AERONAUTICAL CHARTING FORUM
Charting Group
Meeting 15-02 – October 28 - 29, 2015

RECOMMENDATION DOCUMENT

FAA Control # ACF-CG RD 15-02-297

Subject: Charting of HILPT Maximum Holding Altitude

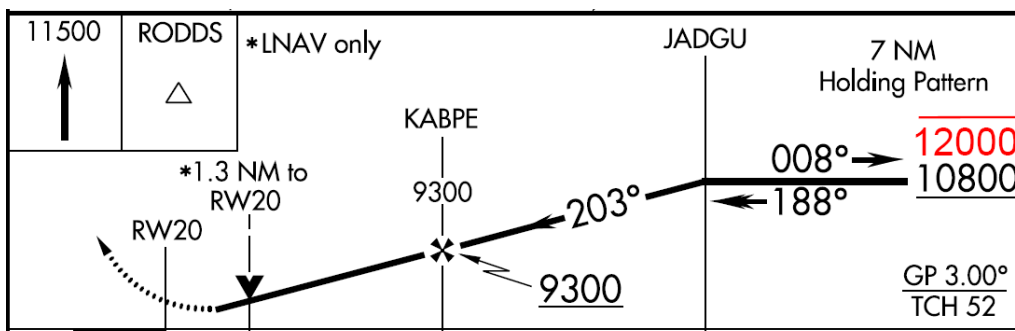
Using the Alamosa RNAV (GPS) Rwy 20 approach example, JADGU would have an “at or below” 12,000’ MSL altitude limit depicted in the profile view, as shown below:

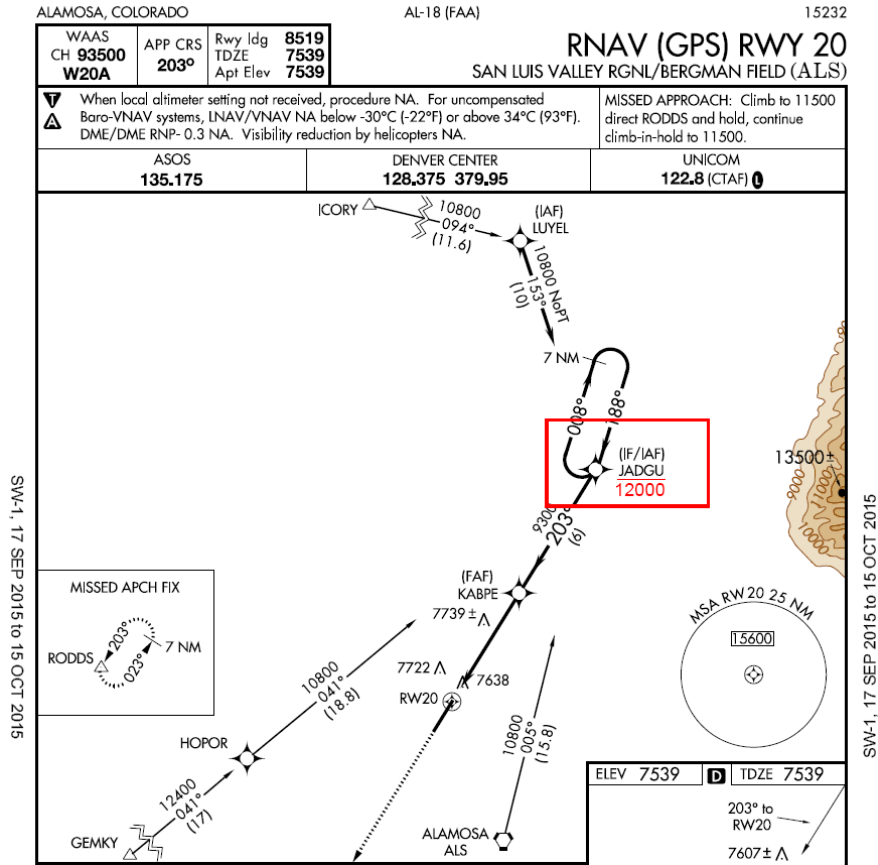
Alternatively, a window, “at or below” and “at or above” altitude can be charted in the profile view. We invite the assistance of the ACF to determine the preferred method:

Figure 1

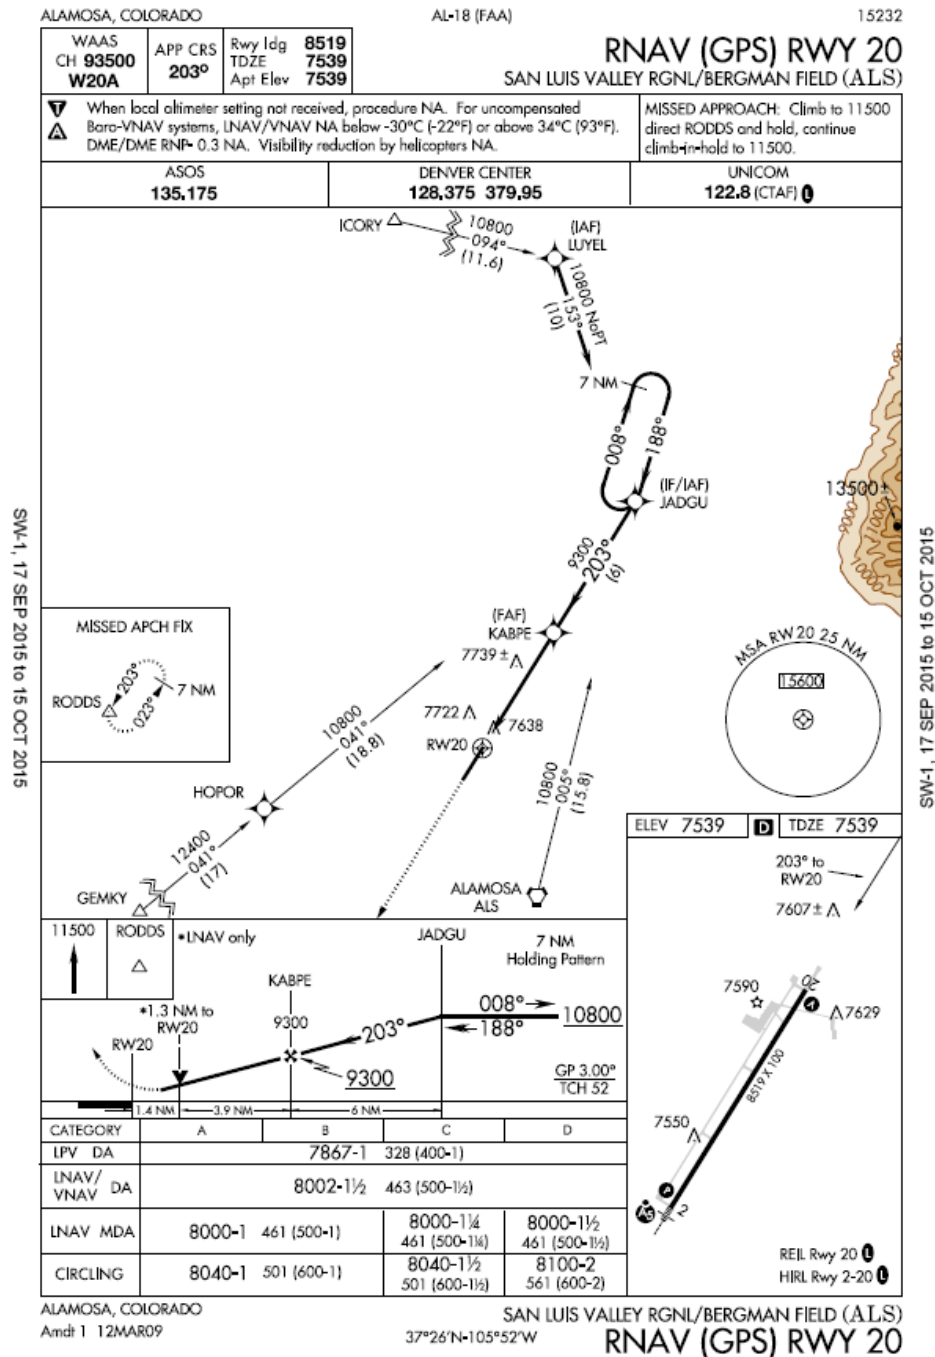
Figure 1 shows the RNAV (GPS) Rwy 20 approach at Alamosa, CO (KALS). The HILPT altitude is 10,800' MSL. Figure 2 shows the FAA 8260-2 Form for JADGU. The maximum holding altitude shown at JADGU is 12,000' MSL. Figure 2 depicts the protected airspace for the HILPT at JADGU based on the P10 pattern. Use of this pattern is required to allow the HILPT protected airspace to remain clear of the terrain to the east of Alamosa. A larger holding pattern would permit holding above 12,000' MSL. However, because of the terrain to the east, the use of a larger holding pattern template is not possible at this location.

Figure 4 shows an overlay of the MIA altitudes in the vicinity of ALS. At most airports, ATC can bring the aircraft to the HILPT at or above the MVA or MIA and below any maximum holding altitude published on the 8260-2 Form. However, at Alamosa the MIAs east of the holding pattern protected airspace are at or above 16000' until just prior to JADGU. It is nearly impossible for ATC to clear an aircraft direct-to JADGU from the east at the 16000' MIA, and then descend the aircraft to cross JADGU at or below 12,000' as required by the holding pattern's maximum altitude prior to clearing it for the approach. This would require a descent of 4000 feet in little over 2 miles.

It is important to note that the airspace above the JADGU holding pattern's protected airspace area that ends at 12,000' MSL and the airspace below the overlying MIA has not been assessed for obstacle clearance as required by 14 CFR part 97. Aircraft operating within this 4,000' zone have no assurance of obstacle clearance if holding in the JADGU holding pattern or executing the HILPT between 12,001' MSL and the MIA.

NBAA proposes that the same charting requirement applicable to a procedure turn when the 10,000’ and below template is used, which is to chart a maximum “at or below” altitude at the IAF, be applied to a HILPT when a maximum holding altitude is specified on the 8260-2 Form. If this maximum holding altitude is specified for ATC-purposes, then this maximum altitude need not be published on the procedure chart.

Figure 5

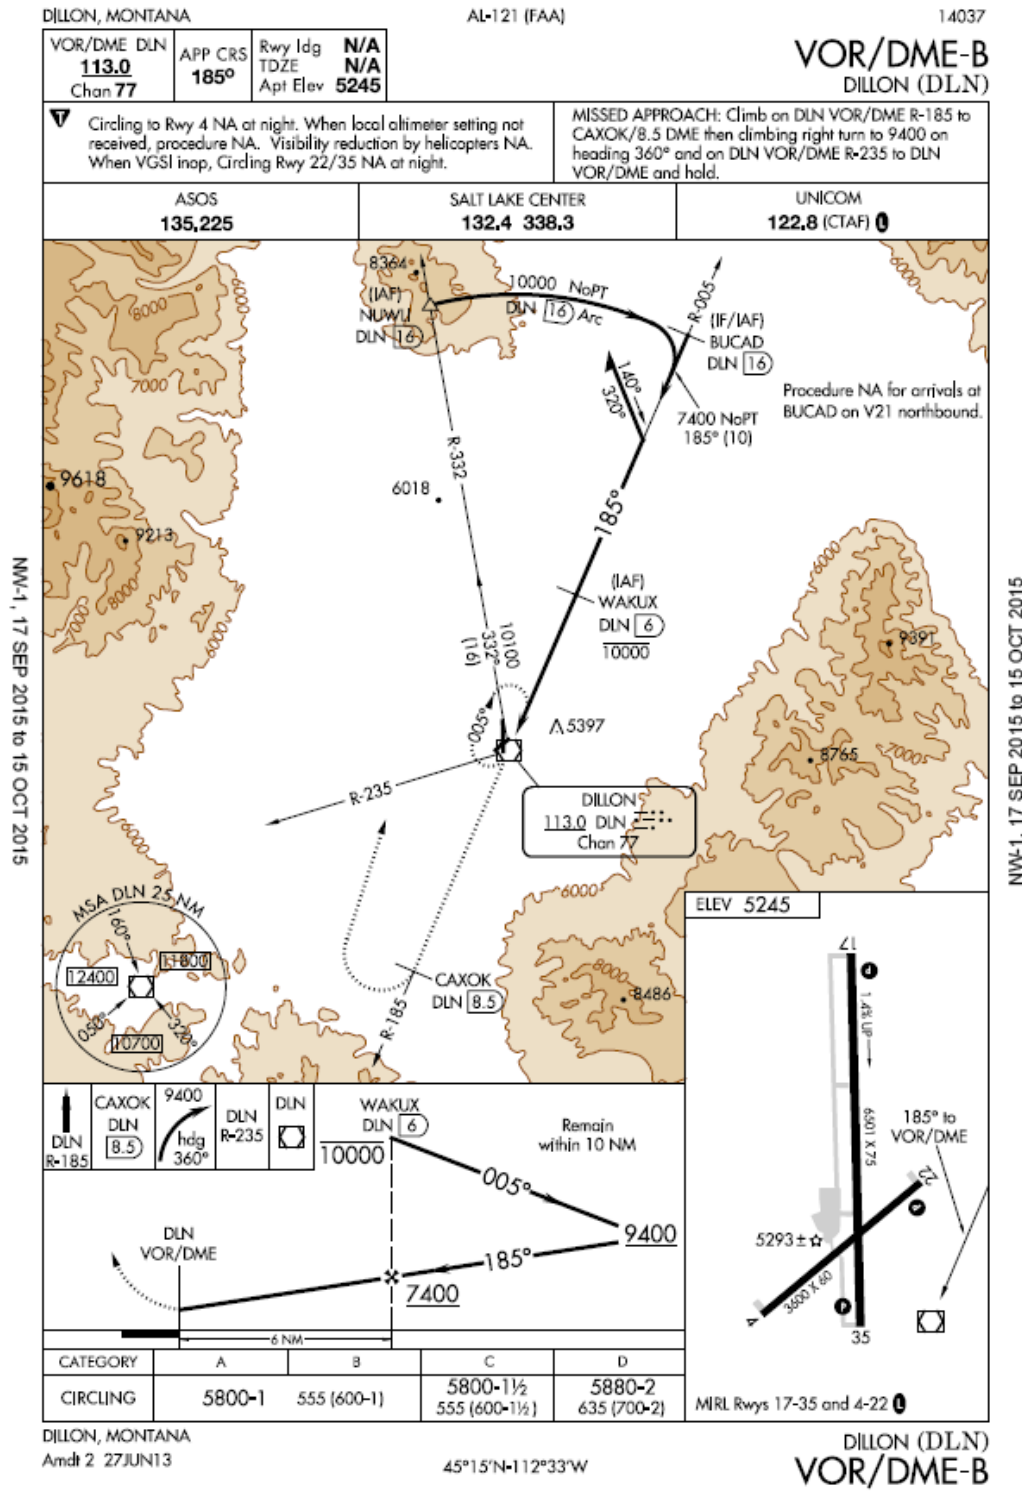
This similar situation exists with procedure turns. Figure 5 shows the VOR/DME – B approach to Dillon, MT (KDLN). The maximum altitude at the IAF (WAKUX) is 10,000’ MSL for entry into the procedure turn. Limiting the maximum altitude at WAKUX permits the use of the TERPS procedure turn protected airspace template specified for use with altitudes 10,000’ MSL and below. If the larger template for above 10,000’ MSL were used, then the procedure turn altitude would need to be raised, which in turn would result in a higher altitude at the FAF.
